C. W. La Monte Company Inc.

March 16, 2022

SUBJECT: RESPONSE TO CYCLE ISSUE COMMENTS-LDR GEOLOGY
Phnx/Chan + Chung Residence
4004 Arroyo Sorrento Rd.
San Diego, CA 92107
Assessor's Parcel Number 307-060-43-00
City of San Diego Project No. 0698398

FIGURE NO. 4C

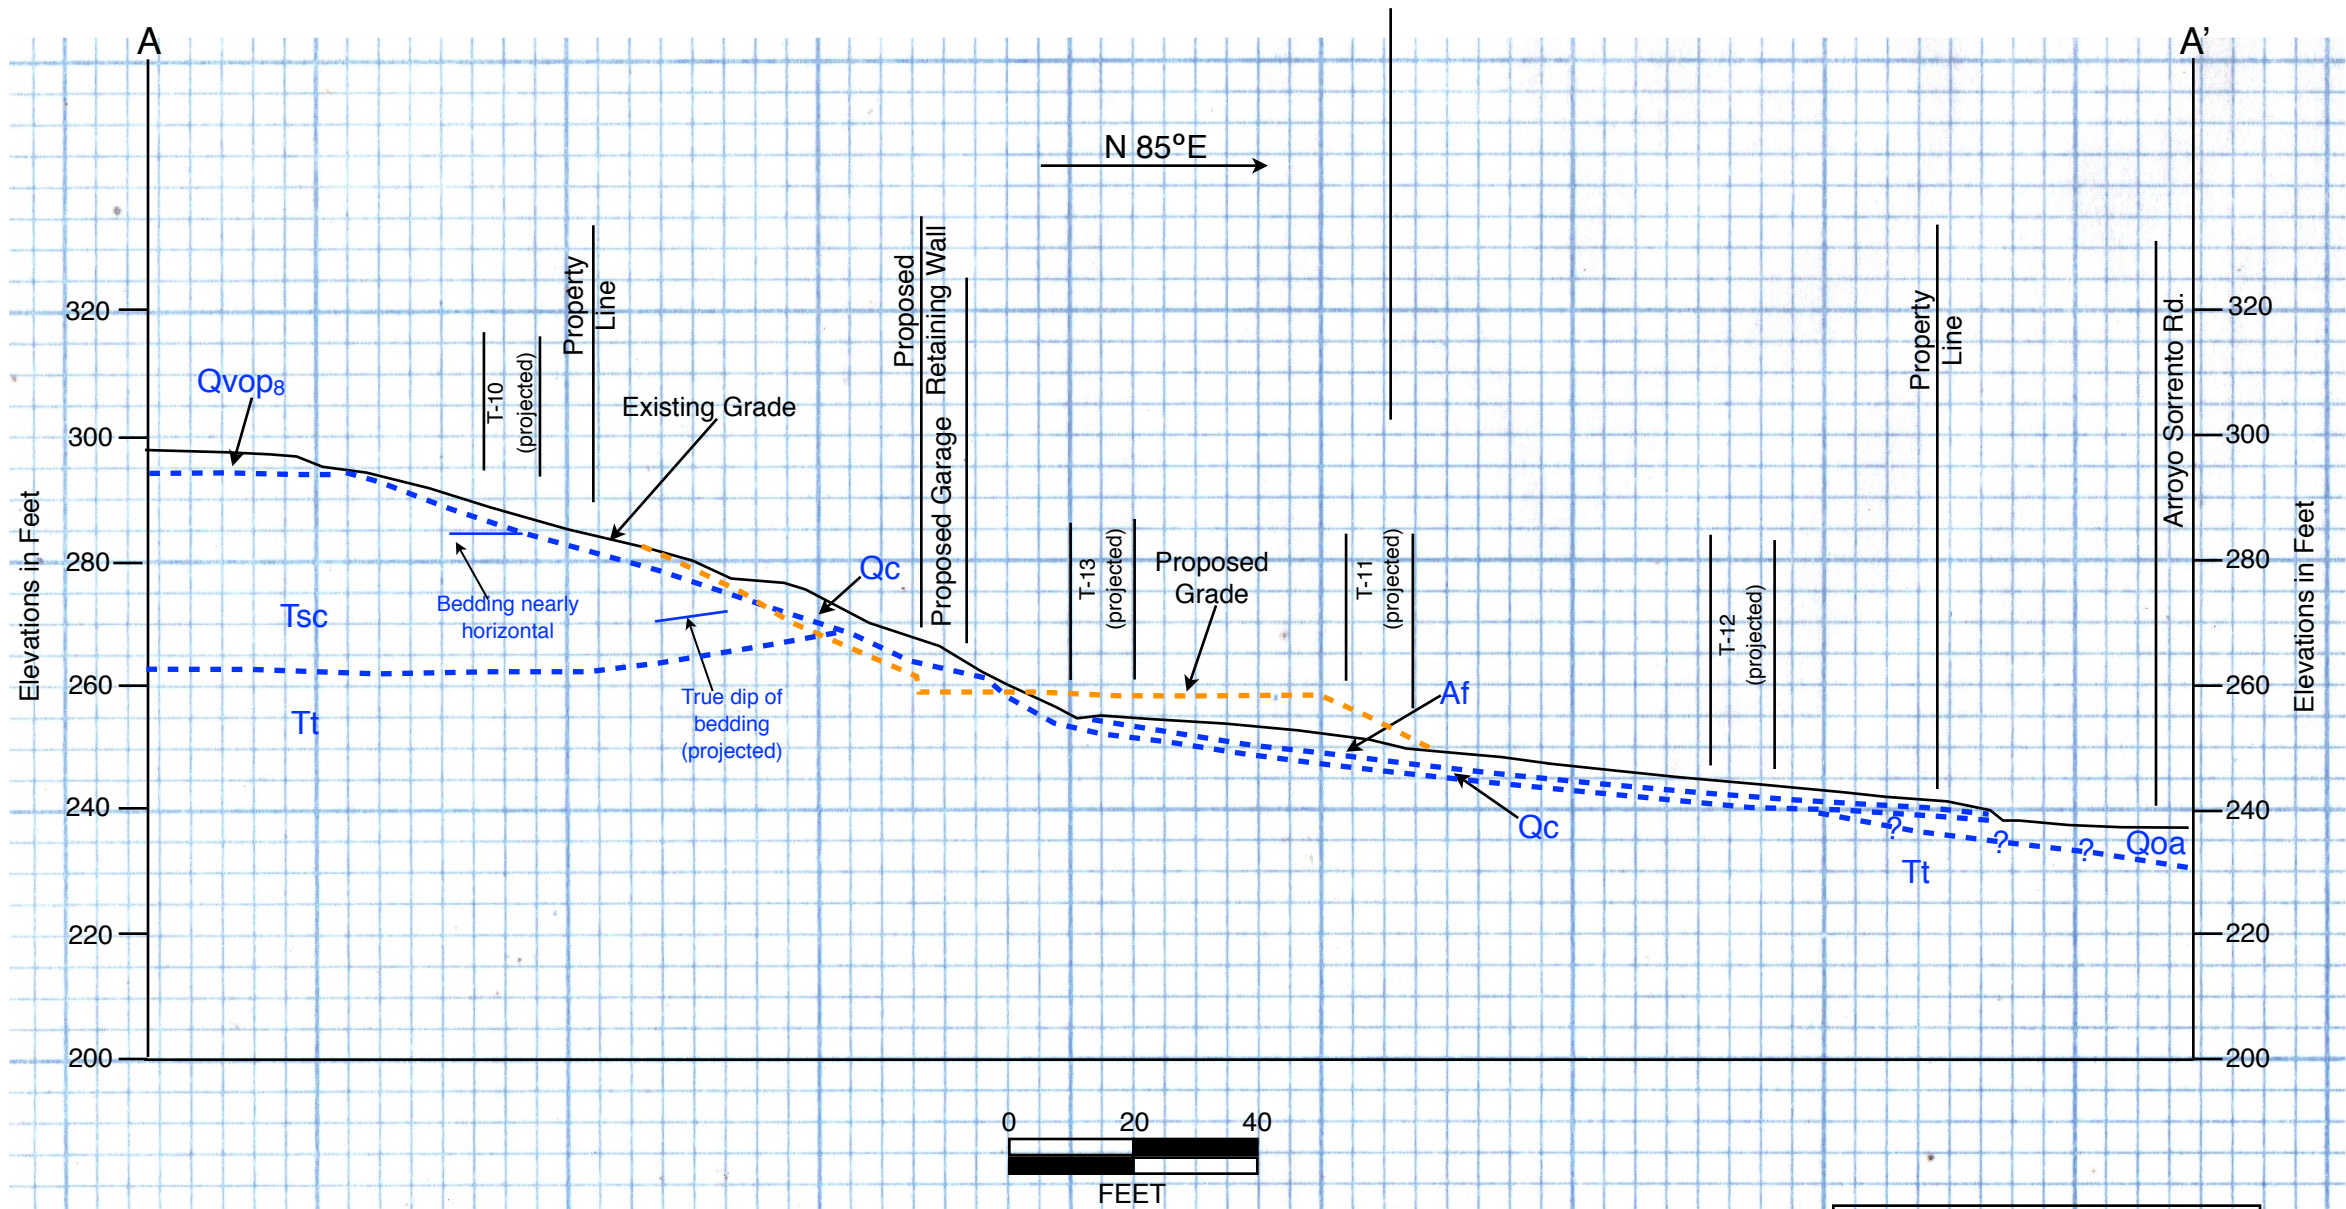
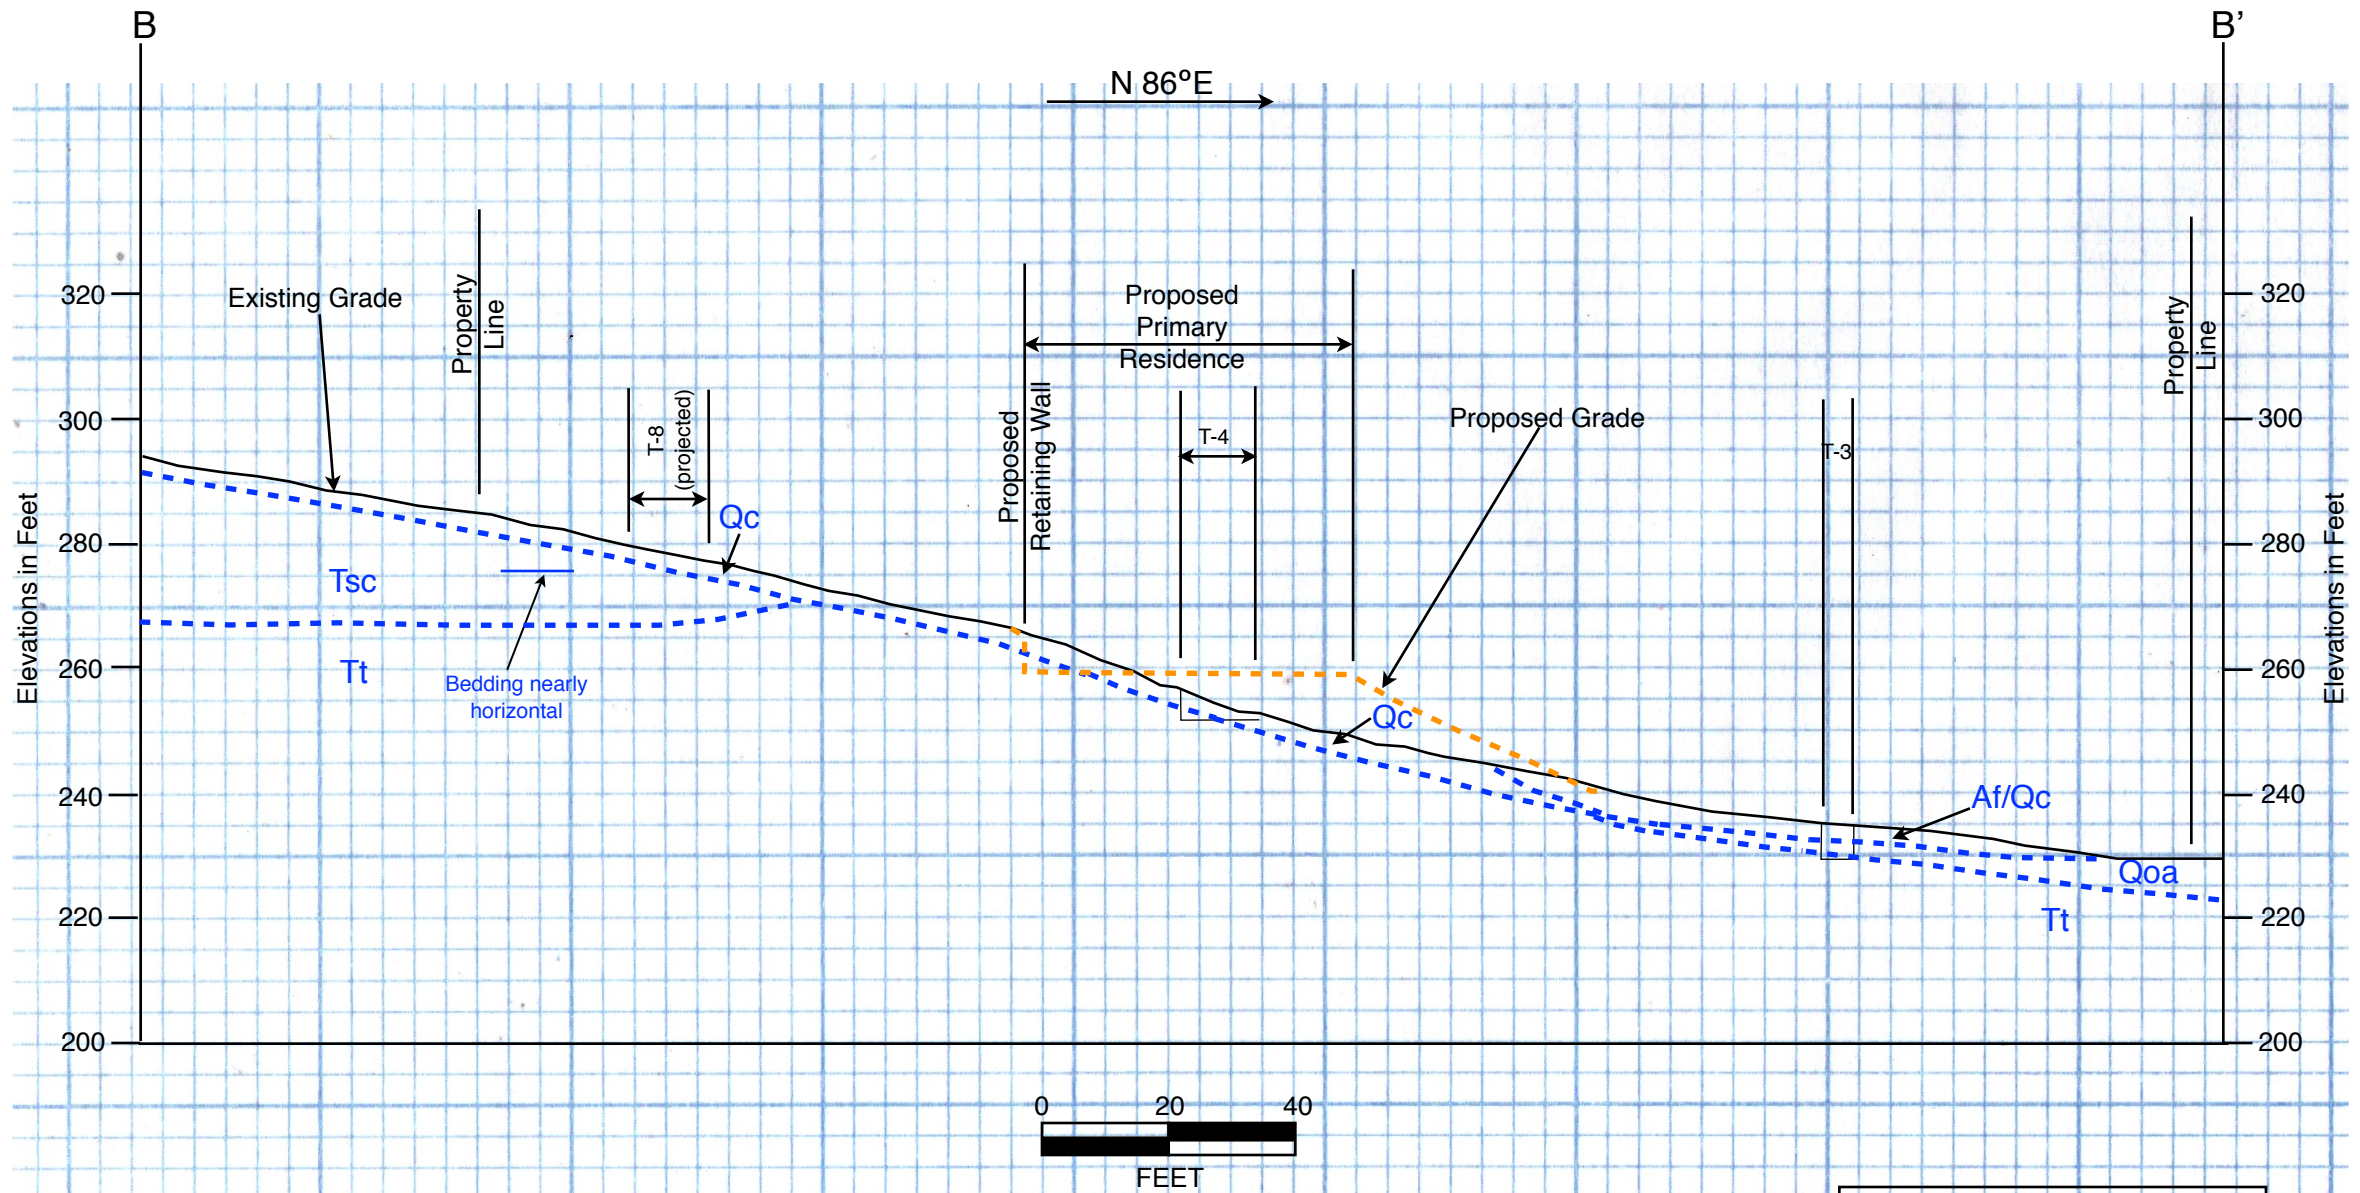
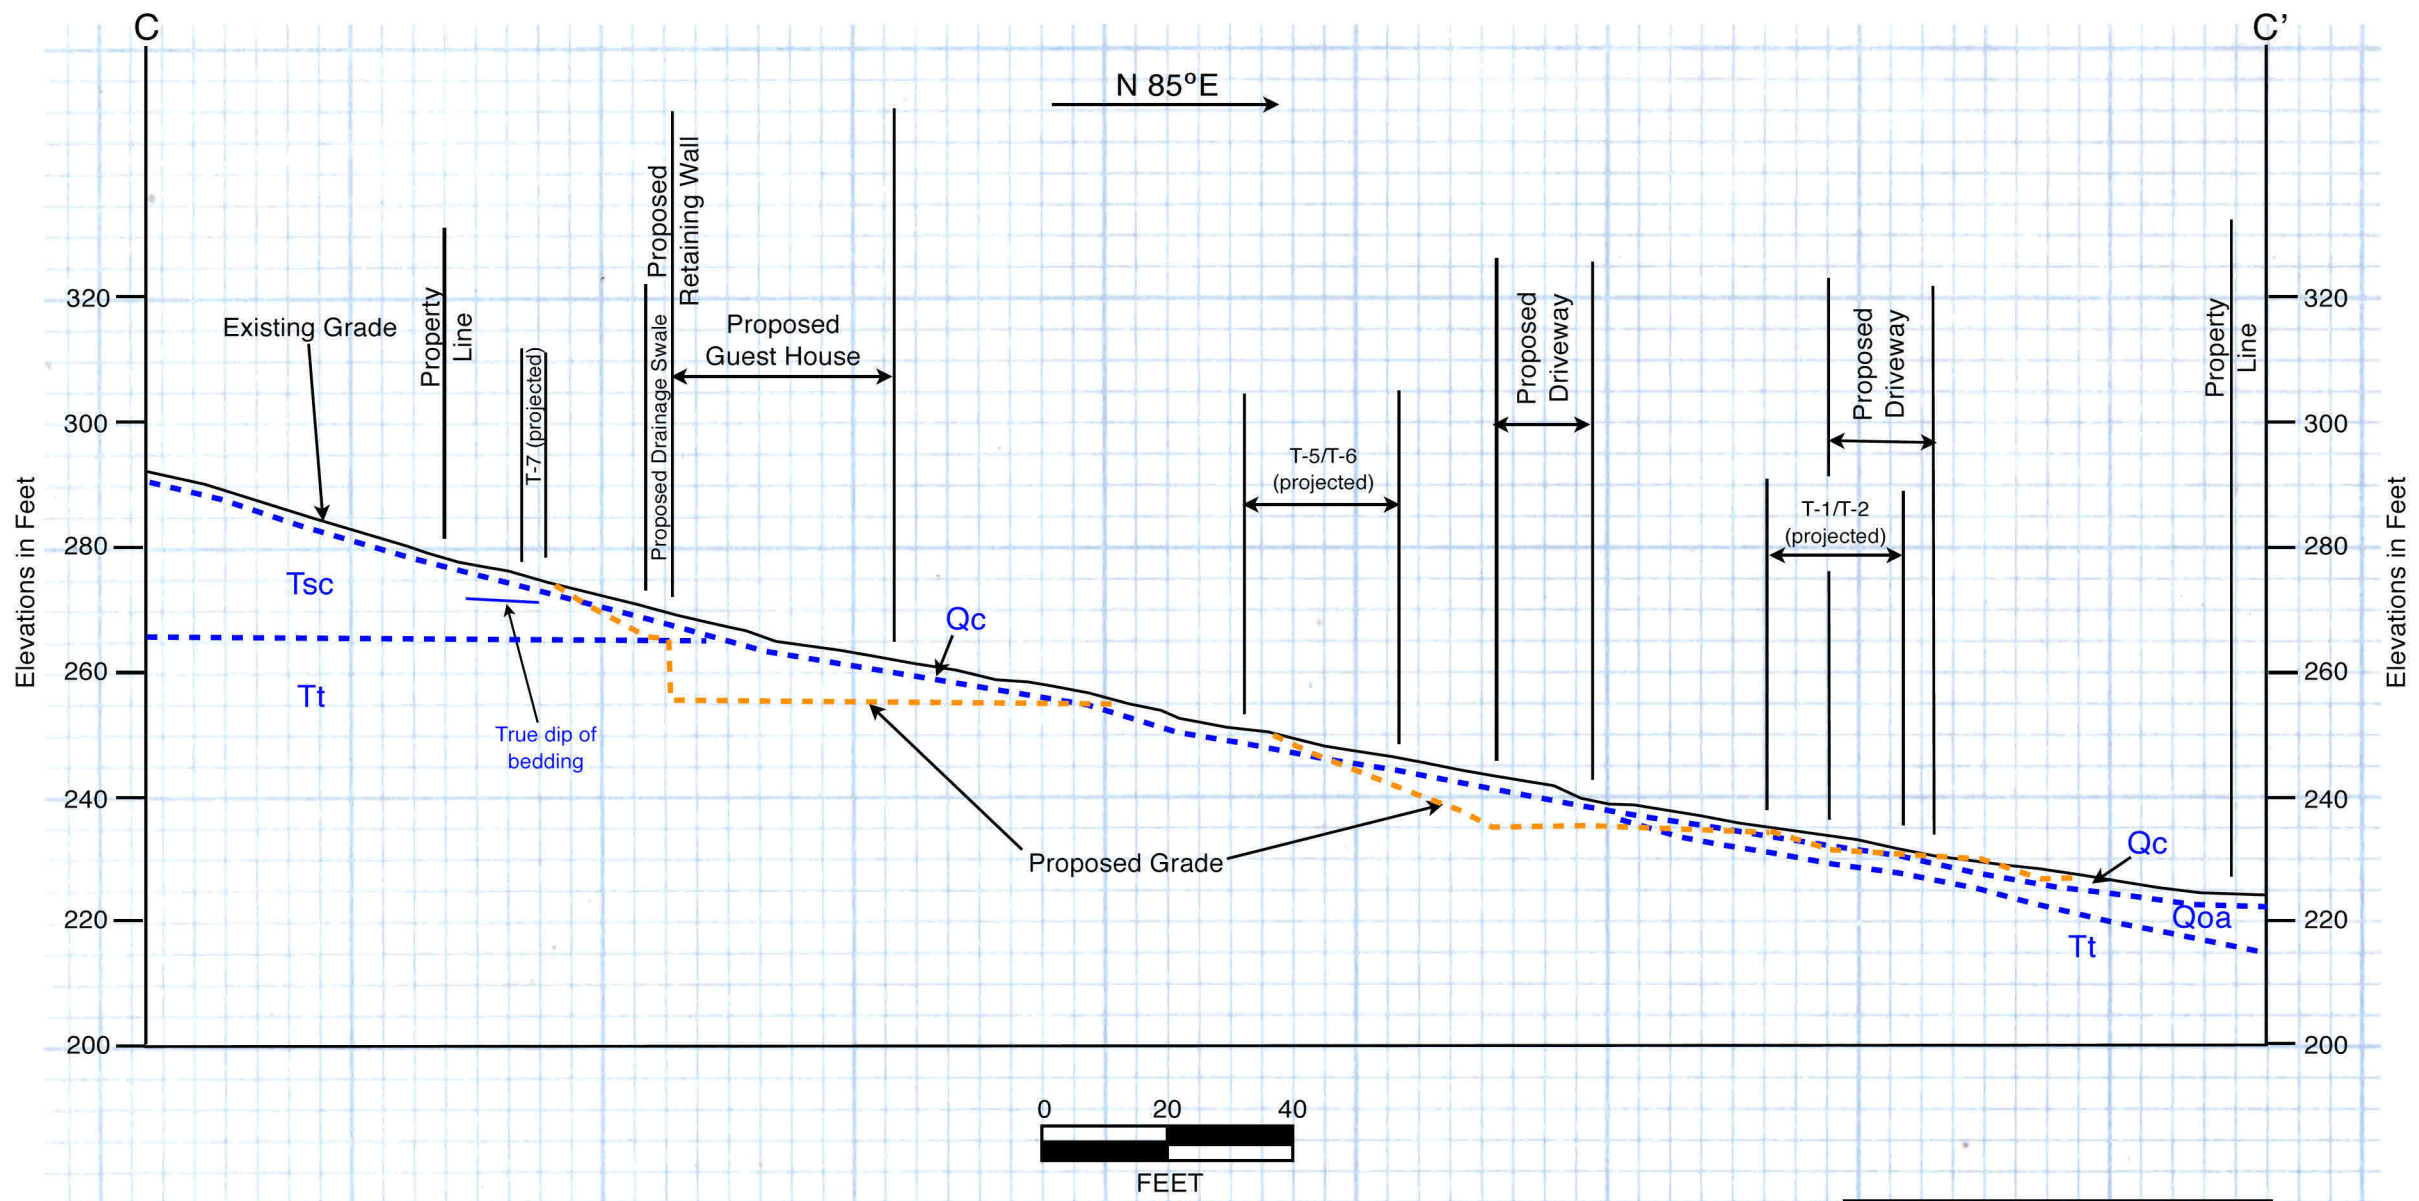
4. *The proposed development appears to have changed since the referenced report was prepared. Provide an updated Site Geologic Map, Figure No. 2B that shows the current proposed construction.*

The Site Geologic Map, Figure 2B, has been updated using the current grading plan as a base map and is attached to this report. Also for easier reference, a copy of the original geologic map (Figure 2A) is attached, which uses the existing topography as a base map. Additionally, the geologic cross sections from the 2017 report have been

updated to include the current proposed grading (Figures 4A through 4C from the 2017 report).
